**DEVELOPMENT REVIEW BOARD MEETING
DECEMBER 11, 2023
6:30 PM**

2. **Resolution No. 422. ParkWorks Industrial Building and Partition.** The applicant is requesting approval of a Stage I Preliminary Plan, Stage 2 Final Plan, Site Design Review, Type C Tree Removal Plan and Tentative Partition Plat for development of an industrial spec building with accessory office space and associated road and site improvements at 26600 SW Parkway Avenue.

**DEVELOPMENT REVIEW BOARD
RESOLUTION NO. 422**

Exhibit A1
Staff Report
Wilsonville Planning Division
ParkWorks Industrial Building
Development Review Board Panel 'A'
Quasi-Judicial Public Hearing

Figure 1: Aerial of Applicant’s Proposed Off-Site Improvements

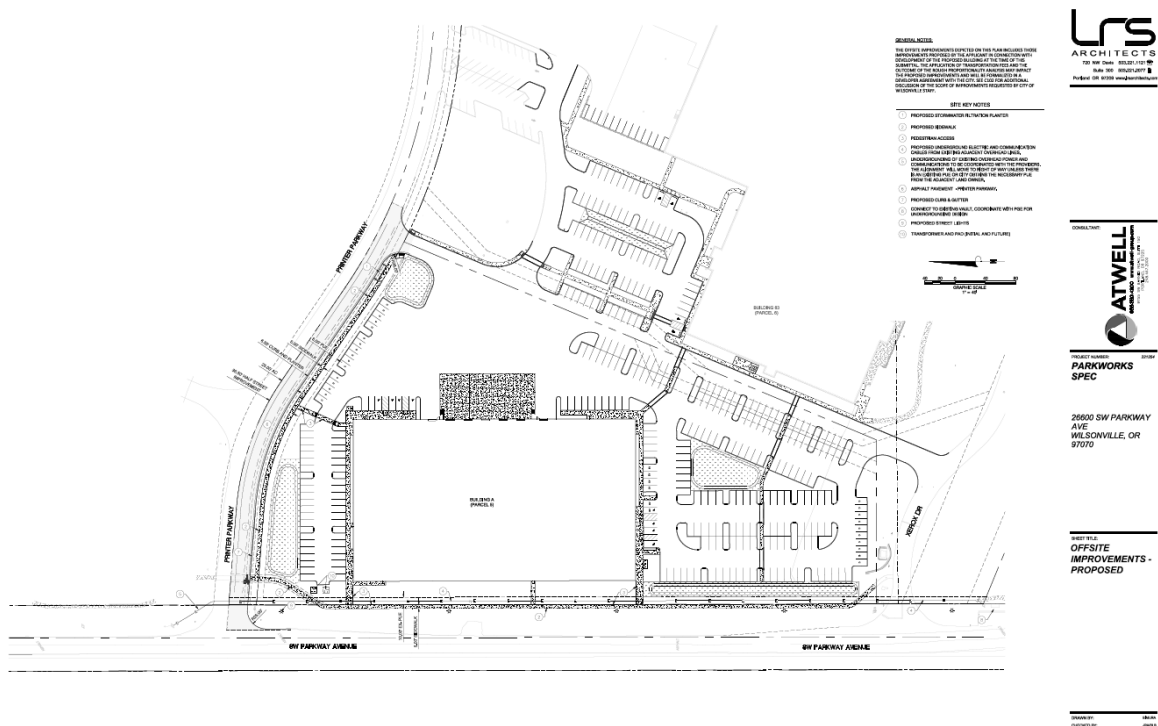
As an initial note, Applicant proposed, in its Application, off-site public improvements that include the full half-street improvement of Printer Parkway to meet the standards of its functional classification as a Collector street. *See* Exhibit B to Application, page 8 (“Offsite Improvements – Proposed”). Applicant’s proposed plan for offsite improvements is provided below as **Figure 1:**

Figure 9: Aerial of Proposed Development and Adjacent Off-Site Improvements

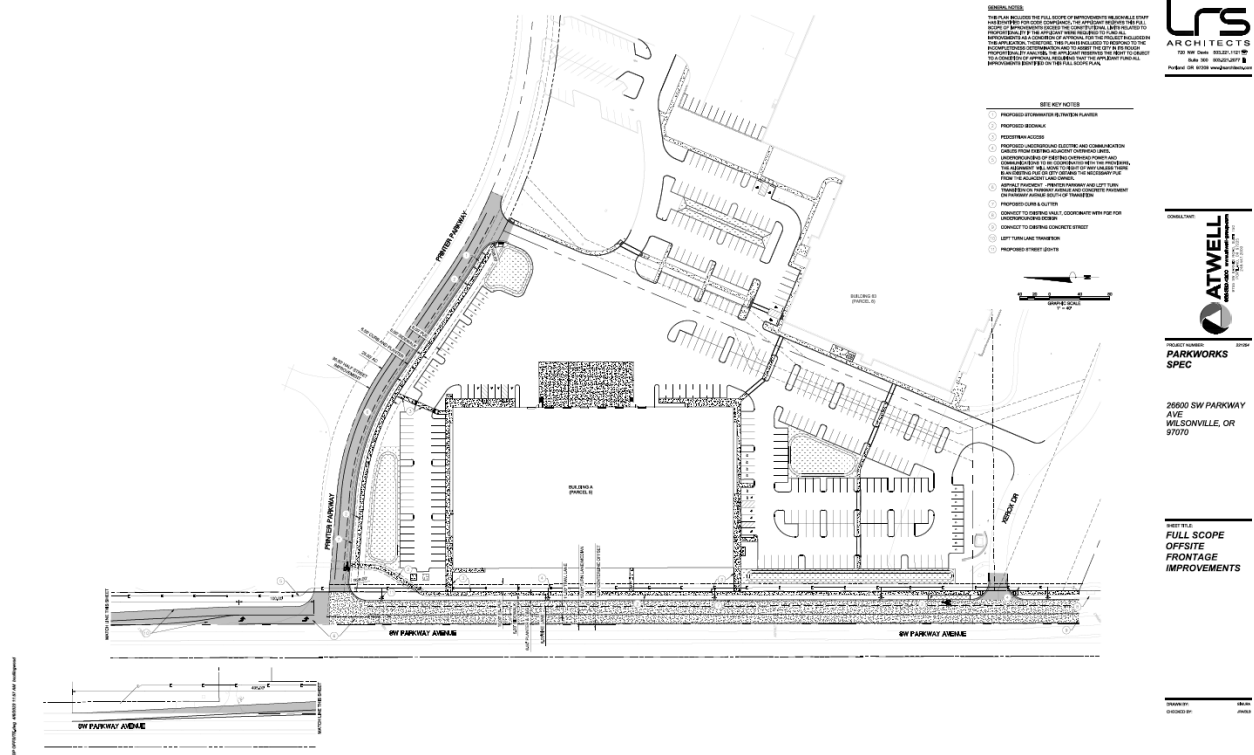
The first four off-site improvements listed above are described in the site plan (Exhibit B to Application, page 9) submitted, with objection, by Applicant provided below (**Figure 9**):

Thus, Applicant is required to construct the following off-site improvements to Parkway along Applicant’s frontage from Printer Parkway to and including Xerox Drive: a 12-foot center median, 11-foot eastern travel lane, 6-foot bicycle lane (with an additional a two-foot buffer), a 6.5-foot planter street and stormwater facility, and a 5-foot sidewalk. The cross-section for a minor arterial from the City TSP is provided as **Figure 10** below.

Figure 11: 1999 Sidewalk Easement Locational Map

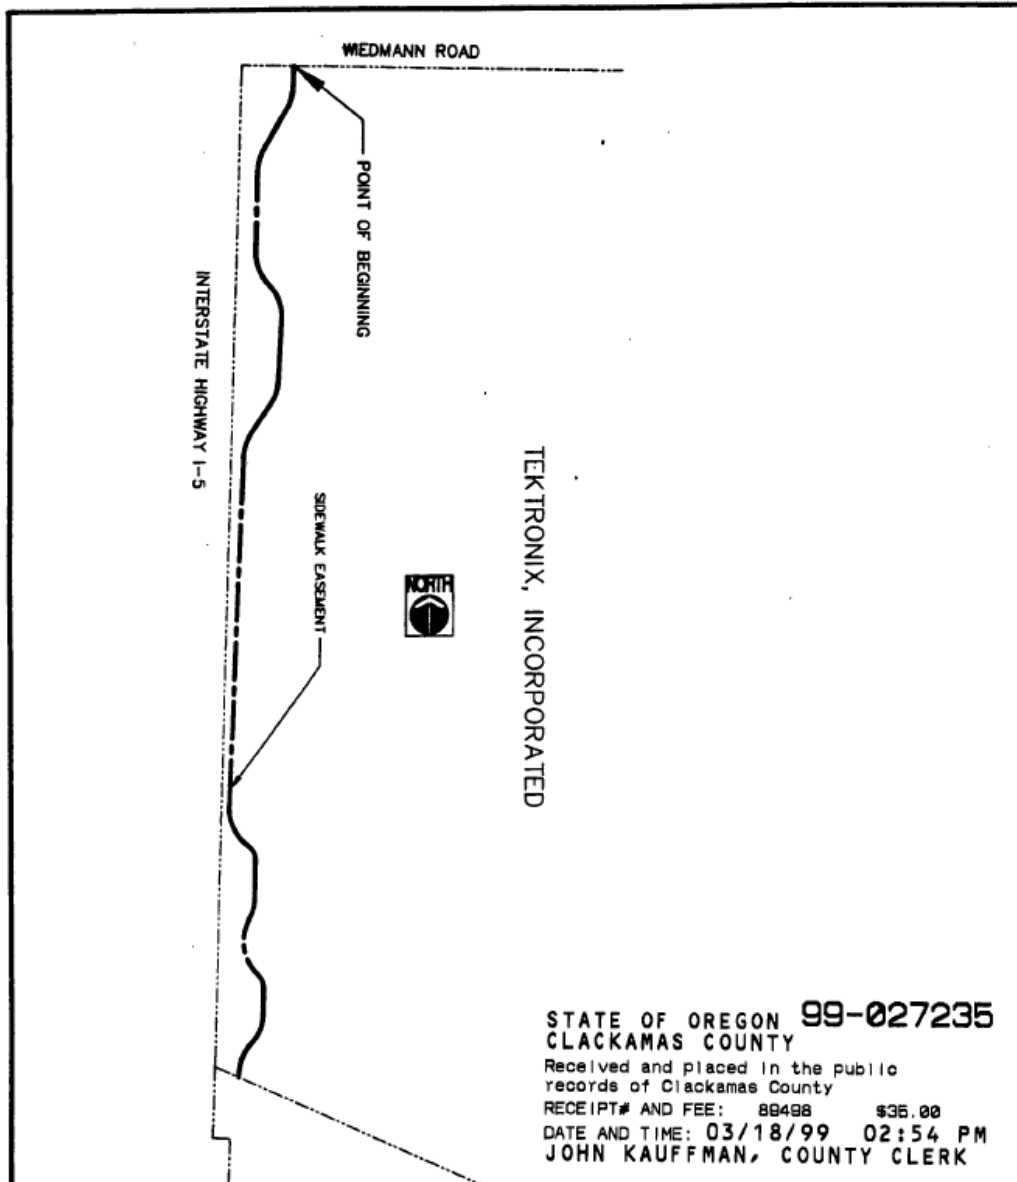
A five-foot sidewalk is also required for the Proposed Development along Parkway pursuant to the Conditions of Approval. The City currently has a sidewalk easement for a ten (10) foot sidewalk along the western portion of the Property, pursuant to a 1999 sidewalk easement recorded in the Clackamas County Official Records as document no. 99-027235 (attached hereto as Attachment 5). The ten-foot sidewalk was constructed and is present adjacent to Parkway, however, there are places where the sidewalk does not meet ADA standards due to cross-section slope issues and at pedestrian crossings of driveways. The locational map of the sidewalk, included in the sidewalk easement, is provided as **Figure 11** below.

The right-of-way for the future cross-section of Parkway that the City acquired in 2015 encompasses the 10-foot sidewalk easement. Since the future five (5) foot sidewalk is part of the minor arterial cross-section, Applicant is simply required to continue to offer a sidewalk as part of the right-of-way, although the City proposes a smaller, ADA-compliant sidewalk of only five (5) feet width, which, when combined with the 6.5 foot planter strip, is roughly equal to the existing sidewalk. To be clear, the City is not requiring any change to the sidewalk, except to ensure compliance with ADA standards and to allow Applicant to lessen the width of the sidewalk to provide the planter strip.

FIGURE 5: LEFT-TURN LANE CONCEPTUAL OVERVIEW

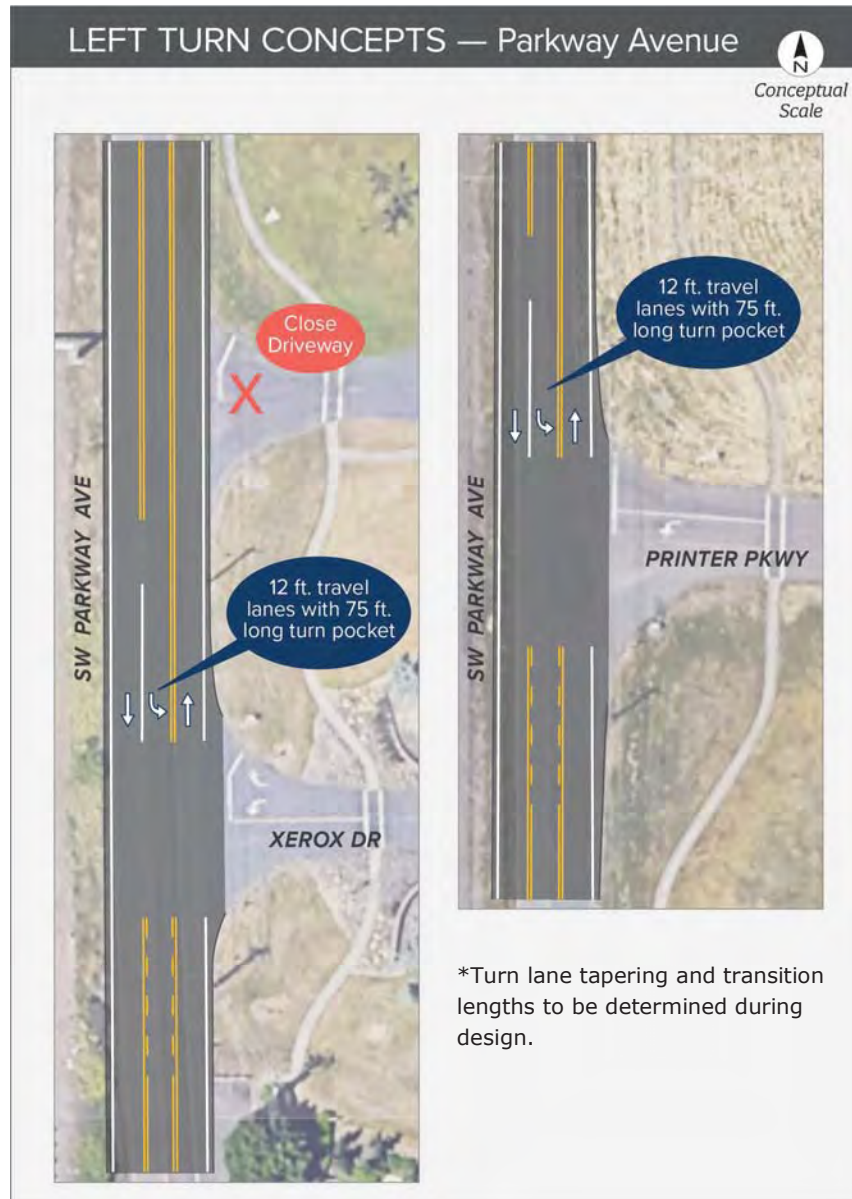
Left-turn storage lengths of 75 feet are recommended at each intersection based on estimated queue lengths derived from the ODOT Two-Way Stop Controlled Intersection Calculator.¹⁴ While the calculator estimates queue lengths of 32 feet at the Printer Parkway intersection and 27 feet at the Xerox Drive intersection, a greater distance is needed for a standard left turn pocket. Additional street widening will need to be dedicated for turn lane deceleration, tapers, and transition requirements. Figure 5 provides a conceptual level overview of what the left-turn needs.

PF 5.	<u>With the Public Works Permit application:</u> Submit construction plans to Engineering showing southbound left-turn lane improvements up to 75 feet in length along SW Parkway Avenue to facilitate southbound left-turn movements as the intersection of SW Parkway Avenue and Xerox Drive. Left-turn lane improvements at this intersection serve other properties and may be eligible for reimbursement in accordance with City Code Section 3.116. <u>Prior to final completeness of the Public Works Permit:</u> All street improvements shall be constructed, inspected and approved by the City.
PF 6.	<u>With the Public Works Permit application:</u> Submit construction plans to Engineering showing separate domestic, irrigation and fire services to serve the new building. All fire hydrants needed to serve the new development shall be publically owned and located in a public water pipeline easement, if necessary. <u>Prior to final completeness of the Public Works Permit:</u> All water system improvements shall be constructed, inspected and approved by the City.

FIGURE 6: MINOR ARTERIAL CROSS SECTION STANDARD

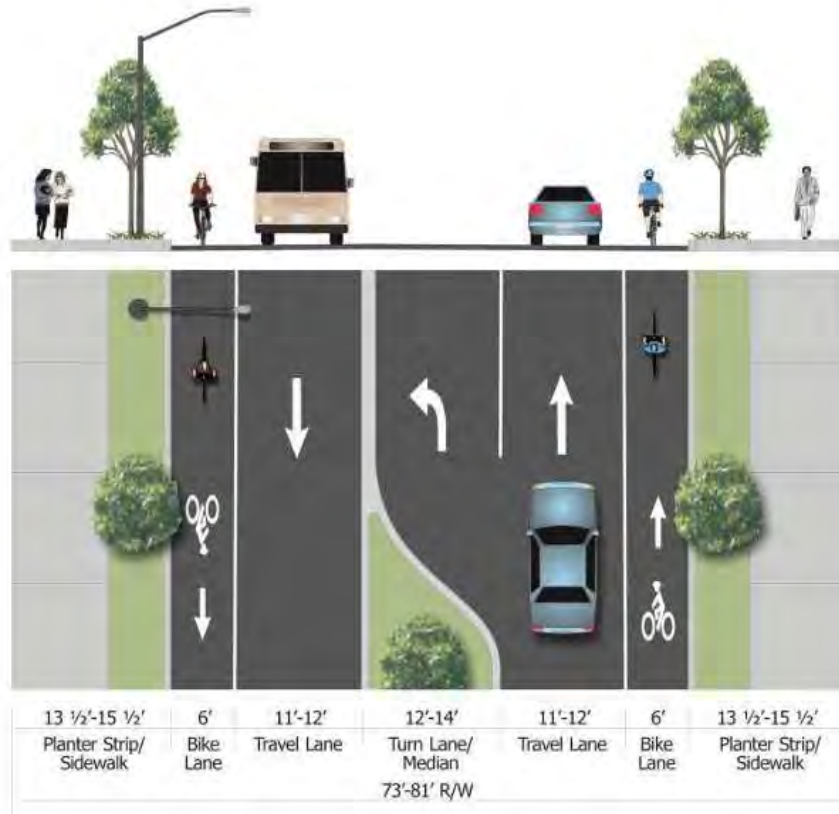
The developer shall coordinate with the City of Wilsonville regarding the required frontage improvements on SW Parkway Avenue. The Minor Arterial street cross-section standard for SW Parkway Avenue is shown in Figure 3-7 in the City TSP and in the figure on the following page.²¹

Based on the standards, SW Parkway Avenue (minor arterial) is to have sidewalks, planter strips, and bike lanes along the project frontage. Minor arterials are also to have a median/center turn lane. As SW Parkway Avenue is also a Freight Route, separation between bicycles and vehicles is recommended.
